1425-1451 East 12th Avenue

Stephen Bohus, BLA, Grandview-Woodland resident and renter

Open House panel on City's Grandview-Woodland Community Plan

Maximum 6,500 ft.² floor plate (6th Floor)

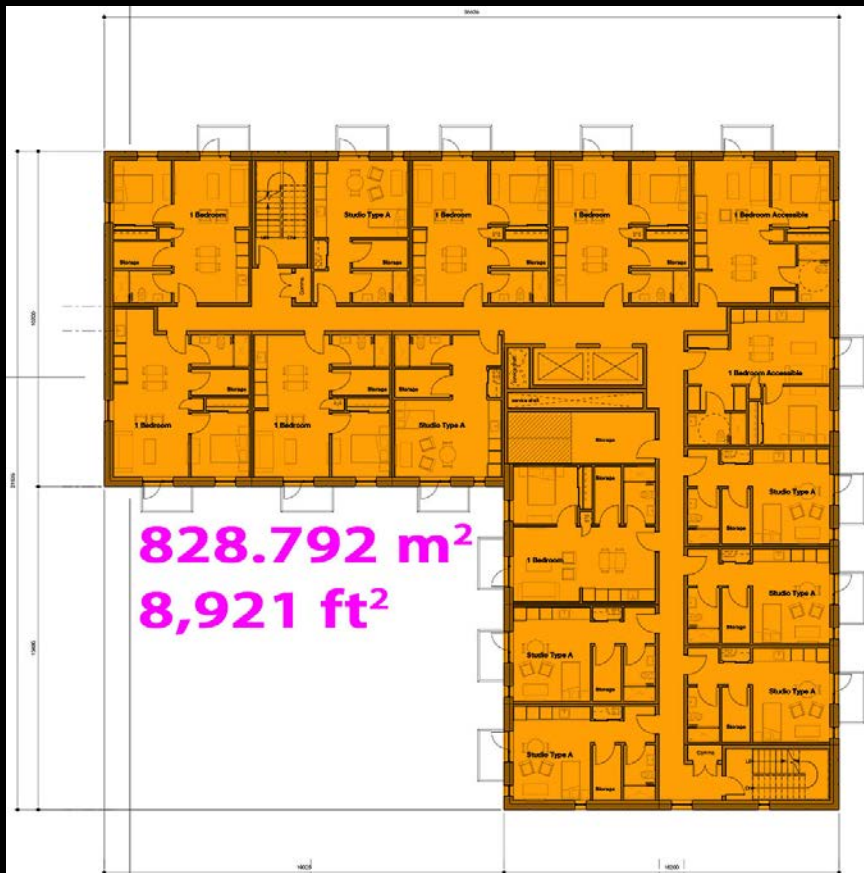
1451 East 12th Avenue floorplate area **does not meet policy.**

- The portion of any building above 18.3 m (60 ft.) in height should not exceed a typical floor plate of 603.9 m² (6,500 ft.²), and should be spaced at least 24.3 m (80 ft.) from any other building above 18.3 m (60 ft.) in height.

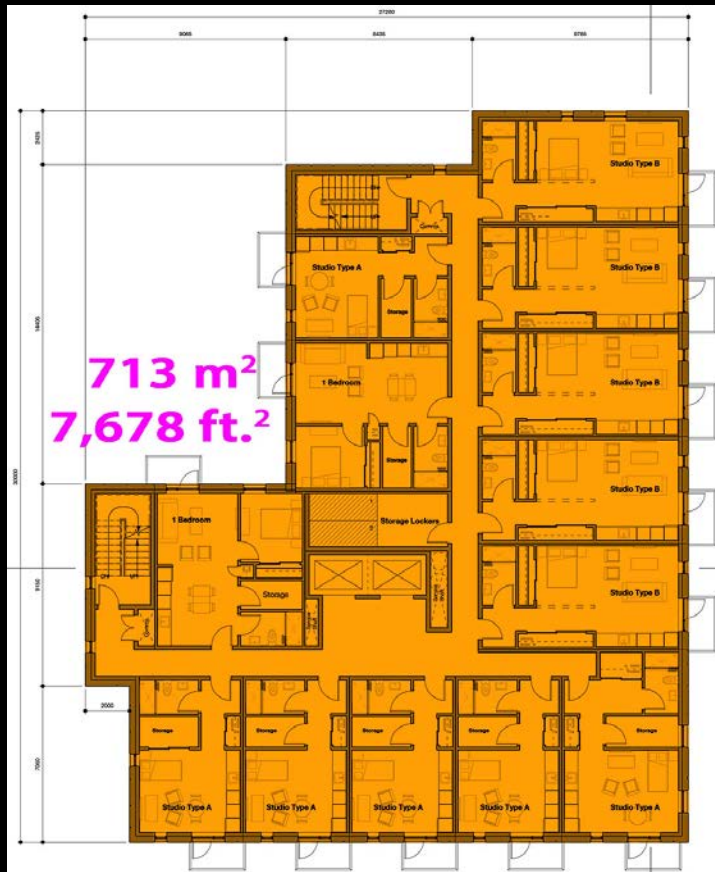
8,921 ft.² exceeds maximum of 6,500 ft.²

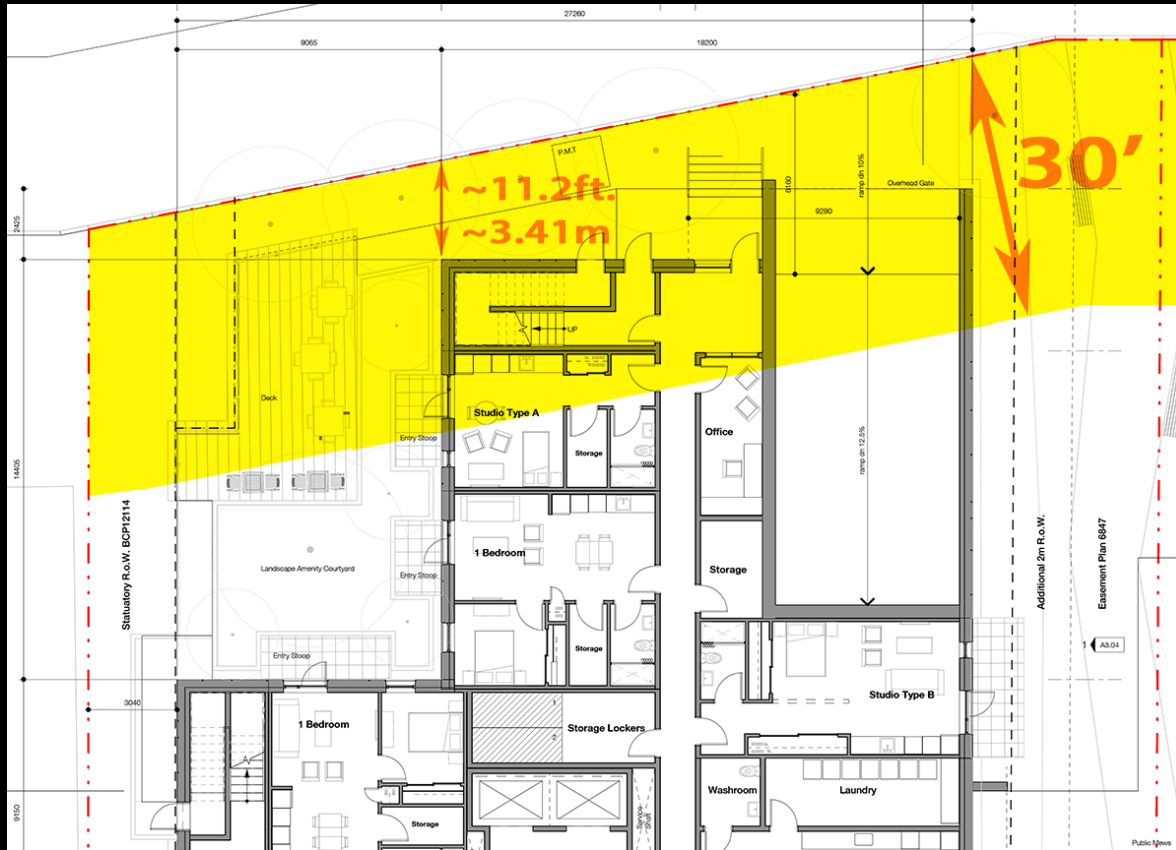
Rear yard setback does not meet policy.

- **Setbacks:** Front: 3 m (10 ft.) / Side: 2.1 m (7 ft.) / **Rear: 9.1 m (30 ft.).**

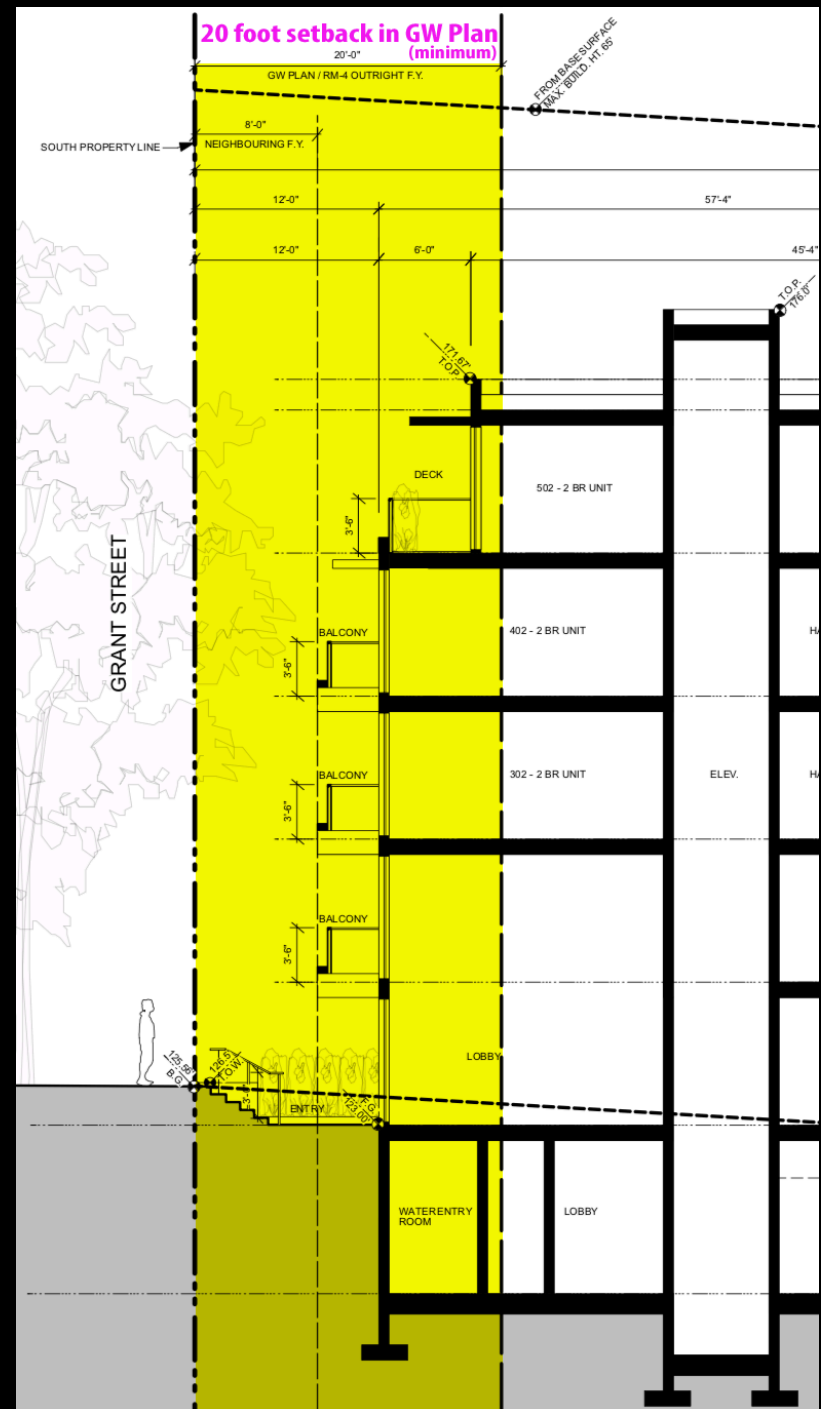
Setbacks: Front 6m (20ft.)

The 1535 Grant Street rezoning application had a 12ft. Front yard setback

and not 20ft as per the plan policy

- Height: up to 6 storeys. [SEP]
- Density: up to 2.4 FSR. [SEP]
- Site frontage: 15.1 m (49.5 ft.) (minimum) to 61 m (200 ft.) (maximum). [SEP]
- Setbacks: **Front 6m (20ft.)** / Side 2.1m (7ft.) / Rear 6m (20ft.). [SEP]
- Require ground-level access for first floor units. [SEP]
